Access Compliance Report

Public Rights-of-Way

(Curb Ramps)

Intersection ID: 47576	Main Street: BARRANDS_LN	Cross Street: SEDGEBURN_DR	Location: NE
ADA ID: B842FF72CBC4	Ramp Type: Perp	Initial Pass/Fail: Fail	Overall Compliance: No
Severity Score: 12.5			
Codes/Mitigation Info/Possible Solution		Field Measurements/Component Compliance

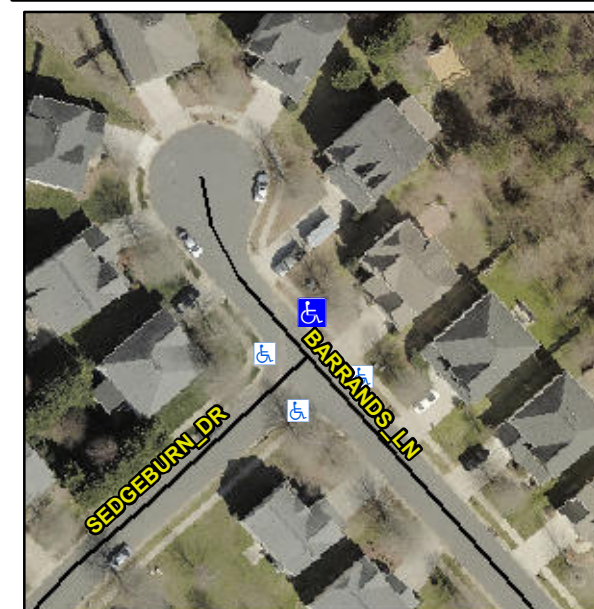
Not Found, R304.2.2

Compliance	Description	Data	Compliance	Description	Data
N/A	Ramp Length (in)	48.0	No	Ramp Slope (%)	8.8
Yes	Ramp Width (in)	48.0	Yes	Ramp XSlope (%)	0.2
N/A	Flare Type LT	N/A	N/A	Flare Type RT	N/A
N/A	Flare Slope LT (%)	N/A	N/A	Flare Slope RT (%)	N/A
N/A	Flare Traversable LT?	N/A	N/A	Flare Traversable RT?	N/A
N/A	Landing Length (in)	N/A	N/A	DWS Provided?	N/A
N/A	Landing Width (in)	N/A	N/A	DWS Contrast?	N/A
N/A	Landing Slope (%)	N/A	N/A	DWS Length (in)	N/A
N/A	Landing X Slope (%)	N/A	N/A	DWS Full Width?	N/A
N/A	Landing Curb? (Y/N)	N/A	N/A	DWS Offset (in)	N/A
N/A	Shared Landing?	N/A			
N/A	Gutter Ponding?	N/A	N/A	Gutter Slope (%)	N/A
N/A	Gutter Lip Ht (in)	N/A	N/A	Gutter X Slope (%)	N/A
N/A	Painted X Walk1?	No	N/A	Painted X Walk2?	N/A
	X Walk 1 Direction	To SW		X Walk 2 Direction	N/A
N/A	X Walk 1 Width (in)	N/A	N/A	X Walk 2 Width (in)	N/A
	X Walk 1 Slope (%)	1.9		X Walk 2 Slope (%)	N/A
	X Walk 1 X Slope (%)	1.4		X Walk 2 X Slope (%)	N/A

Remove & Replace Entire Ramp.
